## Site Technical Query - Form

TQ Number:		Project:																					
<b>CW2144960</b>	<b>-A010- 0116</b>	<b>Oyu Tolgoi Underground Project</b>																					
A. To be completed by or on behalf of the Contractor																							
Contractor/Sub-Contractor Name:	MCS International	Date Response	05/09/2022																				
Contract Title:	Booster Fan installations	Plant Area &	1833																				
Contract No.	CW2144960	Contractor TQ Number:	BF-0415-TQ-0116																				
Discipline Codes (Mandatory) <b>D1</b> (CSA) - <input type="checkbox"/> <b>D2</b> (MP) - <input checked="" type="checkbox"/> <b>D3</b> (E&I) - <input type="checkbox"/> <b>D4</b> (Other) - <input type="checkbox"/>																							
<i>Description of Technical Query (List affected drawings and specifications):</i> <b>1833 area: Exhaust guard issue</b>																							
<p>BF-0731-SRV-0014 was created, because self-closing door exhaust guard mesh was misaligned after pre-install. However, vendor supplied new exhaust guard mesh, newly arrived guard mesh has not reinforcement same as old one.</p>																							
<input type="checkbox"/> Routine		<input checked="" type="checkbox"

**Defect and Recommendation Sheet Photo Appendix****Photo #1****Rods weld of closing door exhaust guard broken****Photo #2****Access platform door hinge is broken****Photo #3****When pre-installed the guard on it misaligned due to no support as per its vendor design**

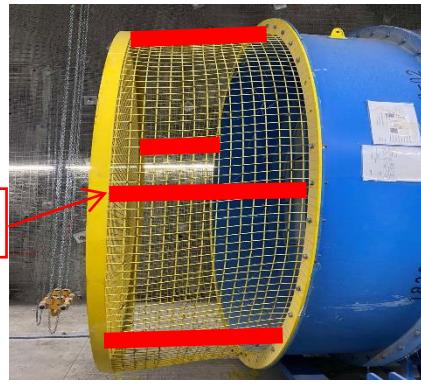
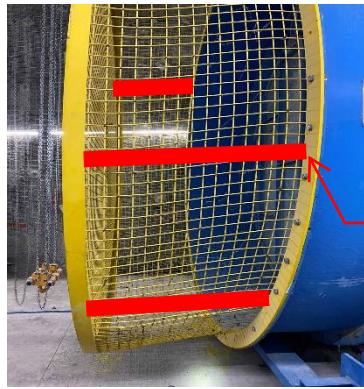
3	Photo #3	<b>When pre-installed the guard on it misaligned due to no support as per its vendor design</b>	Drawing: 1690-55-L4-1528	<b>Provide additional support and notify vendor</b>	Yes	Howden	To be rectified.	Preferred to install additional reinforcing bars between guard flanges. Please refer to sketch on the photo#3 and final detail to be verified by Worley ENG.
4								
5								
6								
7								
8								
9								
10								
11								
12								
13								
14								
15								
16								
17								
18								
19								
20								
to be continue insert new rows if needed.
